March 18, 2020

**Re: Sunset Land Associates LLC and SH Owner LLC
Response to Staff First Submittal Review Comments - Critical Issue
Planning Board Application (PB20-0344, the “Application”)**

TRANSVERSE SECTION PROPOSED

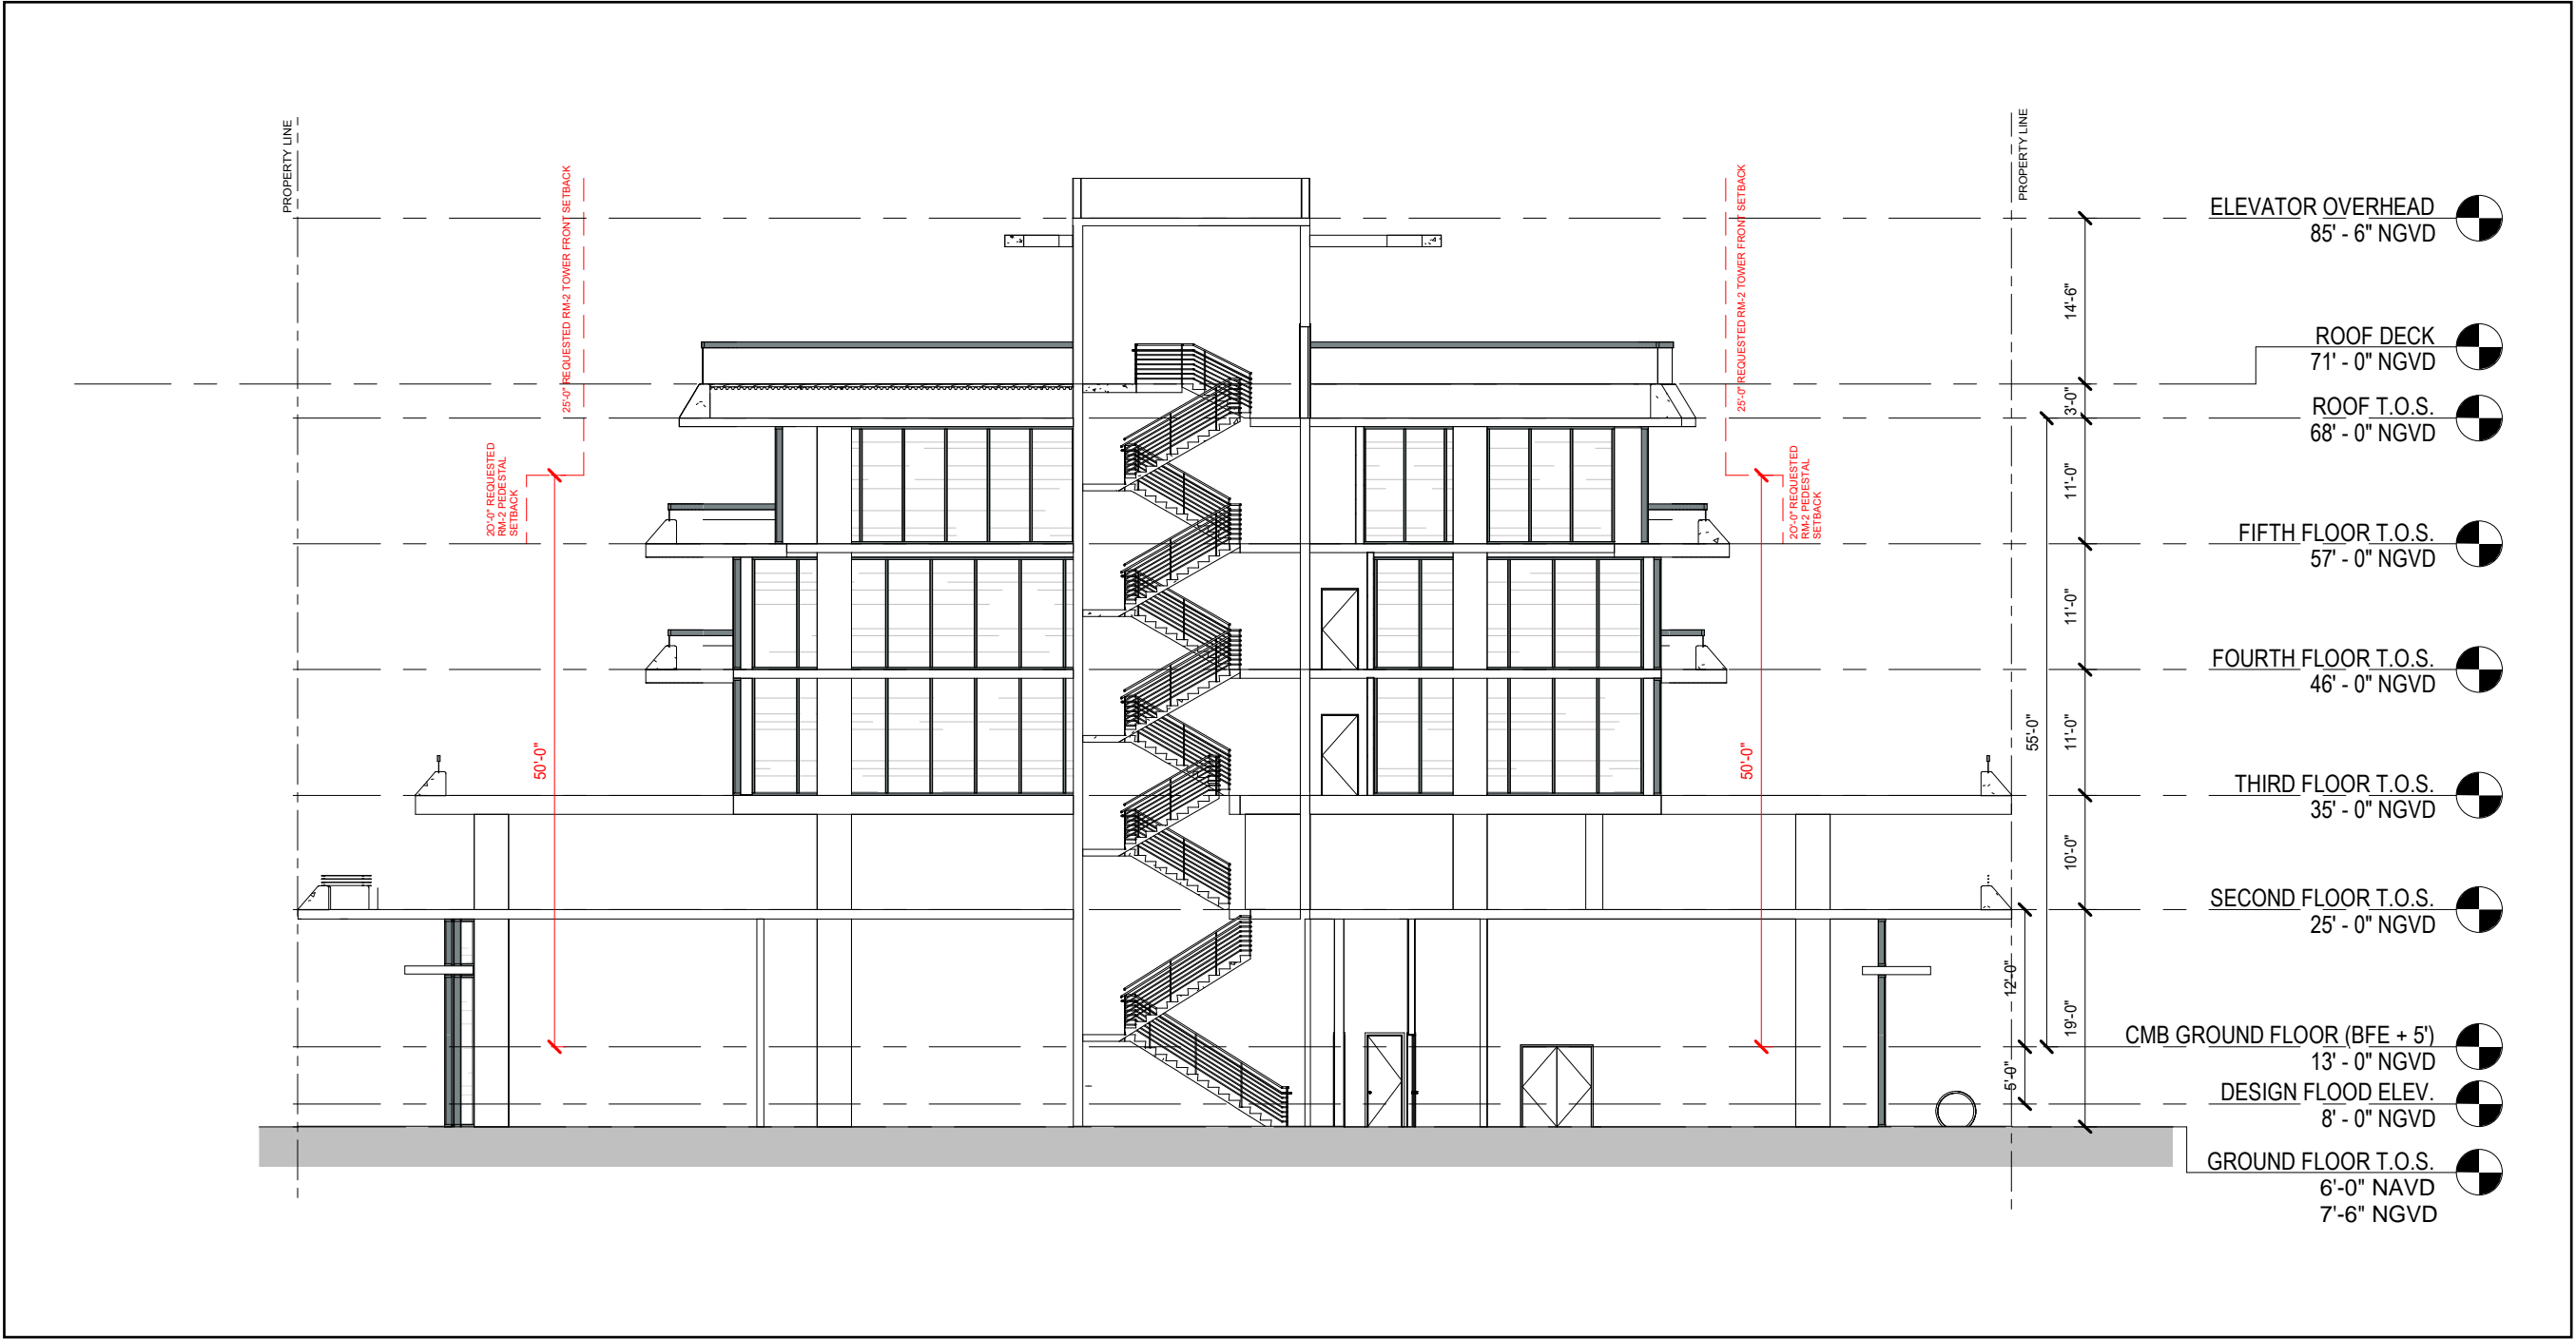
Critical Issue: Staff identified a reduction on the ceiling to floor height on the ground floor and the location of the second level to be lower. This does not comply with CMB code and sea level rise and resiliency review criteria. The first floor shall provide at least 12 feet in height, as measured from the base flood elevation plus maximum freeboard, to the top of the second floor slab in order to get the DRB waiver incentive to measure height from BFE+5 to get the additional 5’ in height as previously approved and shown on page A- 3.8. *Please submit a revised section and elevations for the proposed project By Wednesday March 18, by noon to show compliance. Please make sure all dimensions are legible, as the text is too small. Staff will review this and determine if the applicant can move forward to final submittal or continue to first submittal for PB June Review Cycle.*

Response: Applicant has revised the section and elevations for the project to comply with the City’s Code and sea level rise and resiliency review criteria, as previously approved. Please refer to revised sheets A-3.5 through A-4.0 showing compliance with ceiling to floor height on the ground floor, measured from BFE+5. This submittal has been completed in a timely manner as instructed above.
